| Project                      | <b>IEEE 802.16 Broadband Wireless Access Working Group</b> < <a href="http://ieee802.org/16">http://ieee802.org/16</a> >  |   |
| Title                        | Corrections to DES XOR.   |   |
| Re:                          | Supporting document for recirculation ballot #14b.  |   |
| Abstract                     | In P802.16 REVd/D5 [1], the text indicates that you have to XOR the IV of the DES encryption key with the PHY sync field from the map. But that SYNC field is missing. This contribution proposes an alternative to fix that  |   |

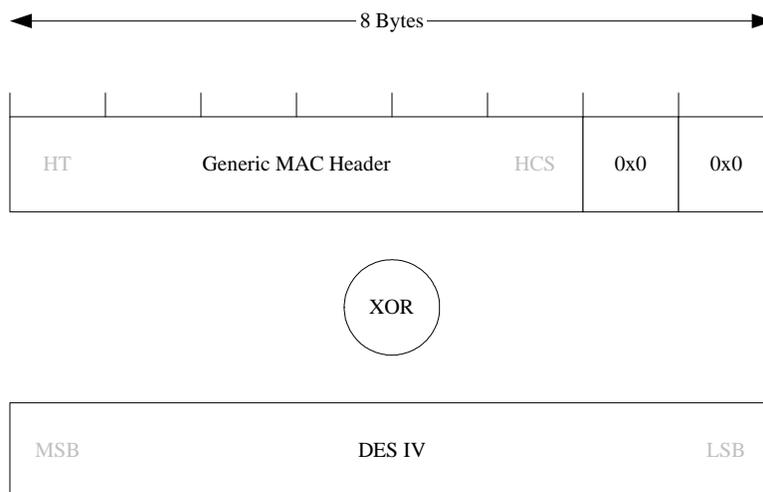
Rather than doing the XOR with the PHY sync field we can do the XOR with the Generic MAC Header of the received / transmitted packet. In this case the operation will be done as follows:

1. Compute the HCS
2. XOR the generic MAC header padded by zeros as shown in the figure below with the appropriate IV, to produce the final IV to be used by the encryption engine.

1. Compute the HCS on the received generic MAC header
2. XOR the Generic MAC Header padded by zeros as shown in the figure above with the appropriate IV., to produce the final IV to be used by the decryption engine
3. proceed to decryptions

Figure NNN. CBC IV computation

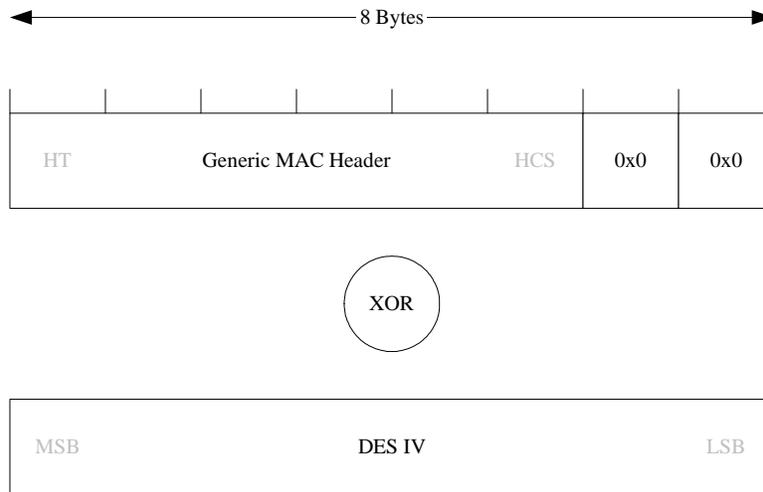
[Section 7.5.1.1 change the second paragraph accordingly]

The CBC IV shall be calculated as follows: in the downlink **and uplink**, the CBC shall be initialized with the exclusive-or (XOR) of (1) the IV parameter included in the TEK keying information, and (2) ~~the content of the PHY Synchronization field (right justified) of the latest DL-MAP~~ **the Generic MAC Header of the MAC PDU being transmitted or received as shown in the following diagram.**
